Responses to Comments on Emission Estimates in the General Air Conformity
Analysis Report

Responses to Comments on Emission Estimates
BNP-2011-180, General Air Conformity Analysis Report,
October 7, 2011

Reference: PADEP-2011-209, email from C. Trostle, PADEP, to B. Wise, PPL, "Comments on Emission Estimates, November 4, 2001.

BELL BEND NUCLEAR POWER PLANT
 LIMIT OF DISTURBANCE
 PPL BELL BEND, LLC
 100 N. BELL BEND ROAD
 BELL BEND, TN 37020

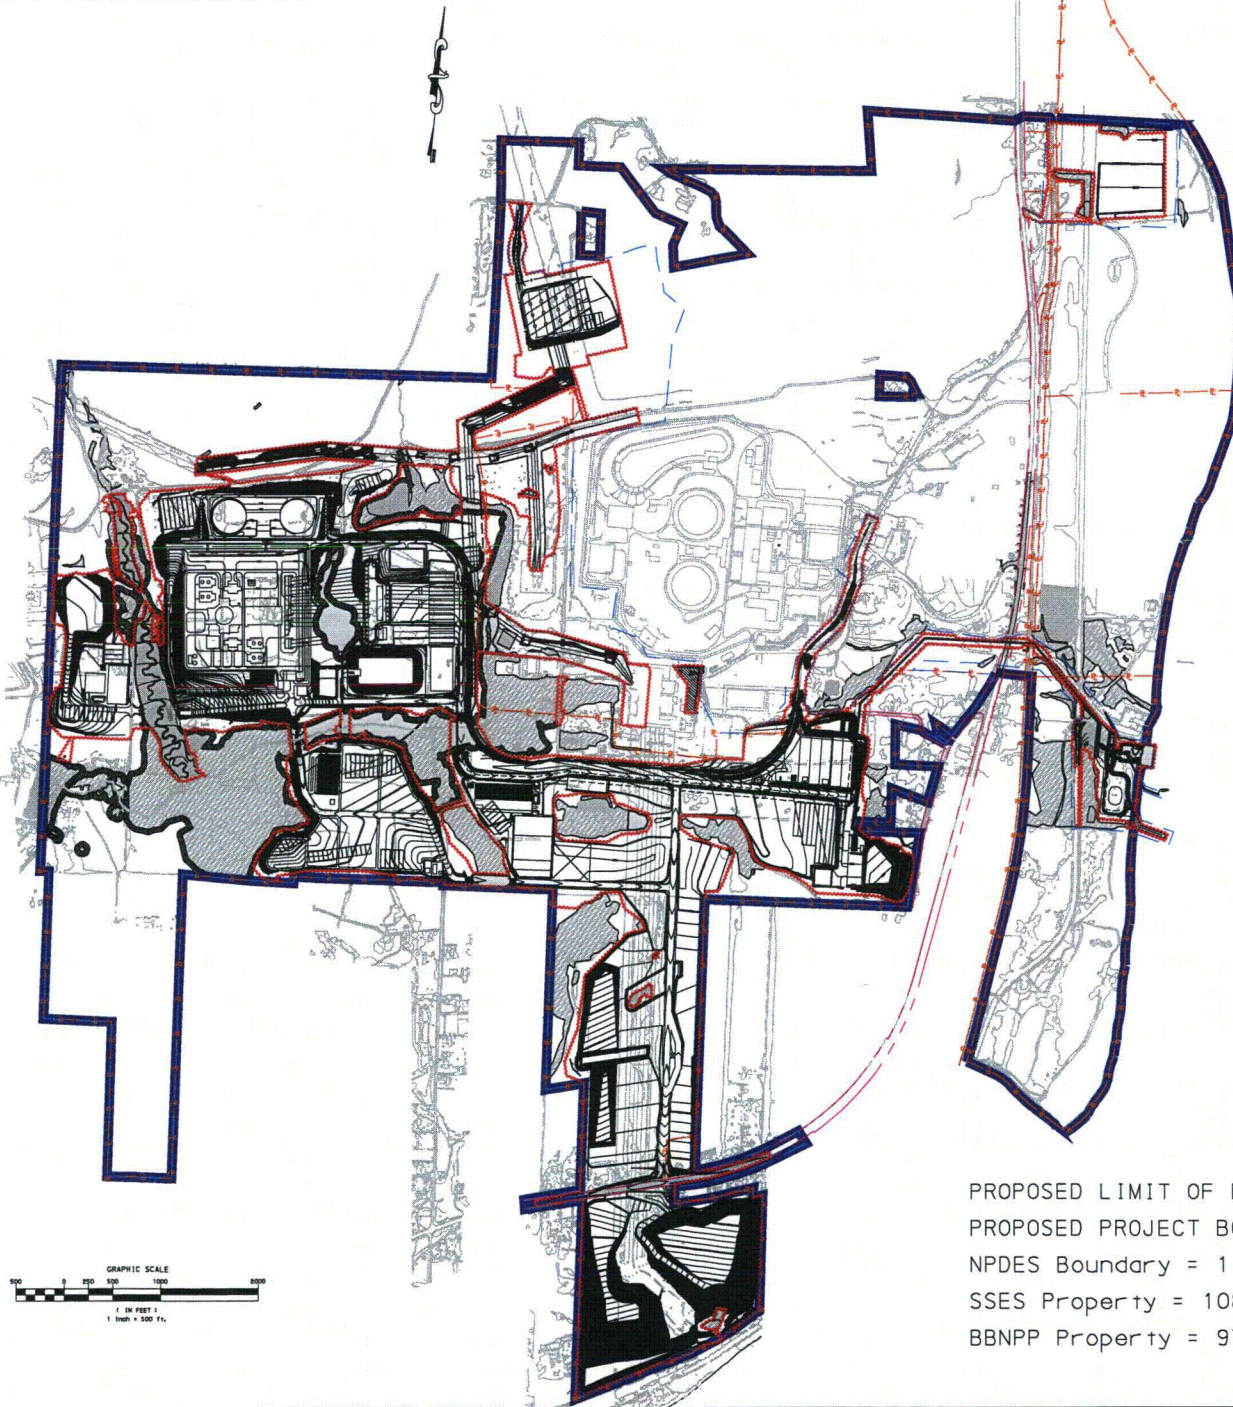
- 1. The Report needs to have a map/aerial view of the project site that has a scale that denotes distance and identifies areas of the individual tasks where the soil will be moved on site. This allows us to get some sense of the amount of hours that dump trucks will operate. Dump trucks used for soil excavating projects like this project are a source for large amounts of emissions. It would be good for us have some idea of dump truck activities.

See attachment 1 for a drawing that shows the Project Boundary and the on-site Limit of Disturbance. Scale is 1 inch = 500 ft. This drawing along with the Attachment 2, Appendix A, Excess Earthwork Reduction Evaluation Areas drawing provides a good overview of where soil will be moved on-site. With respect to the use of dump trucks, see General Response B above.

EXCESS EARTHWORK REDUCTION EVALUATION AREAS

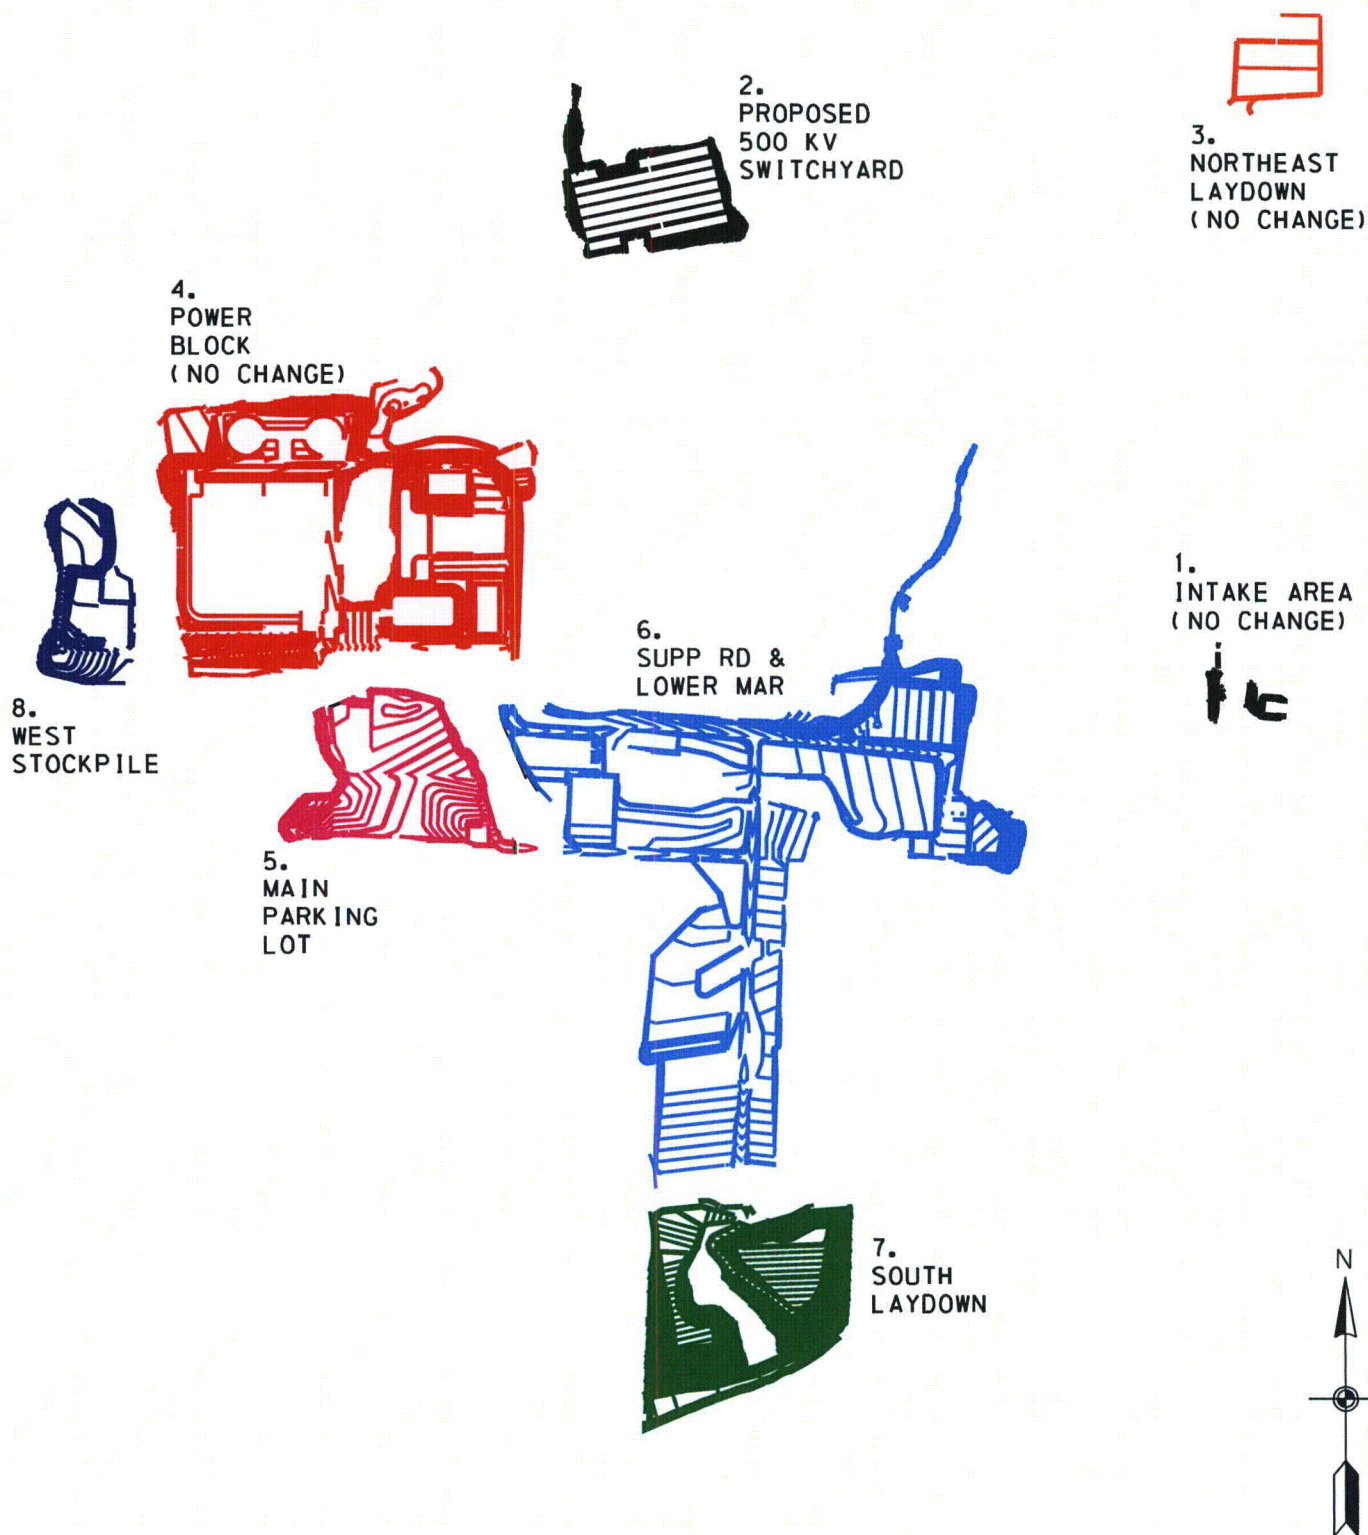
3. Please describe from where and to where the topsoil will be transported on site.

Attachment 2 is the Pennoni Excess Cut Report, Rev 2 (6/16/11) which served as the basis document for the S&L Fuel Usage Report. This report includes the necessary descriptions of what is being moved and where it is being placed. Attachment 3 is the S&L Conceptual Grading and Earthwork Report, (SL-009459) of August 31, 2011. It provides a break out of Top Soil, Competent Rock and Weathered Rock and provides bulking factors for each. An explanation was provided during a conference call with the PADEP as to how to read the Construction Fuel Consumption Information Table that provided the type of vehicles and hours of operation for each defined task per year.
